MOBILE LOGISTICS PARK SUBDIVISION, UNIT ONE

<u>Engineering Comments</u>: FINAL PLAT COMMENTS (should be addressed prior to submitting the FINAL PLAT for review and/or signature by the City Engineer):

The plat illustrates the proposed 1-lot, $4.8\pm$ acre subdivision which is located on the South side of Colgate Drive, $50'\pm$ West of Rangeline Road, within Council District 4. The applicant states that the subdivision is served by city water and sanitary sewer systems. The purpose of this application is to create one (1) legal lot of record from five (5) existing legal lots of record.

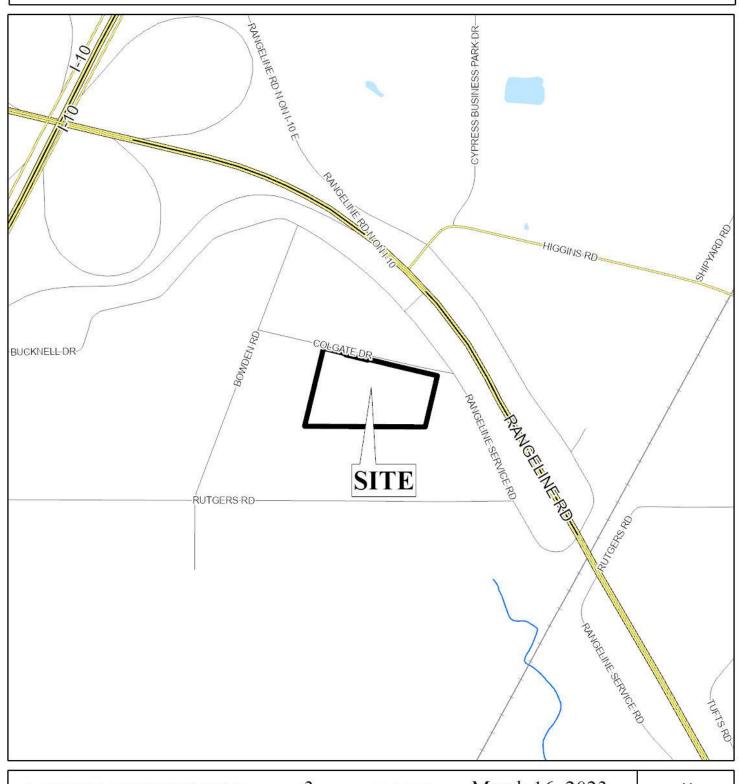
In accordance with the Subdivision Regulations, the proposed lot exceeds the minimum size requirements, and the lot is labeled with its size in both square feet and acres on the preliminary plat. The lot size label should be retained on the Final Plat, if approved, or a table should be furnished on the Final Plat providing the same information. The plat illustrates the 25-foot minimum building setback line along Colgate Drive, and this should also be retained on the Final Plat, if approved.

The proposed lot fronts Colgate Drive, a minor street without curb and gutter, but with a compliant 60-foot right-of-way width; therefore, no dedication would be required. As on the preliminary plat, the street name label and right-of-way width should be retained on the Final Plat, if approved.

No easements are indicated on the preliminary plat. If easements are Indicted on the Final Plat, a note should be required on the Final Plat stating that no structures may be placed or constructed within any easement without the permission of the easement holder.

It should be noted that the subject site has a pending Land Disturbance permit application under review for a lay-down yard. As the site is zoned I-1, the proposed use is allowed by right. The existing dwelling on one of the existing lots is proposed to remain; however, a residence is not an allowed use in an I-1 district.

Based upon the preceding, the plat meets the minimum requirements of the Subdivision Regulations and is recommended for Tentative Approval, subject to the following conditions:

- 1) retention of the lot size label in both square feet and acres on the Final Plat, or the furnishing of a table on the Final Plat providing the same information;

- 2) retention of the 25-foot minimum building setback line along Colgate Drive on the Final Plat;
- 3) retention of the street name label and right-of-way width on the Final Plat;

- 4) if easements are to be indicated on the Final Plat, placement of a note on the Final Plat stating that no structures may be placed or constructed within any easement without the permission of the easement holder;
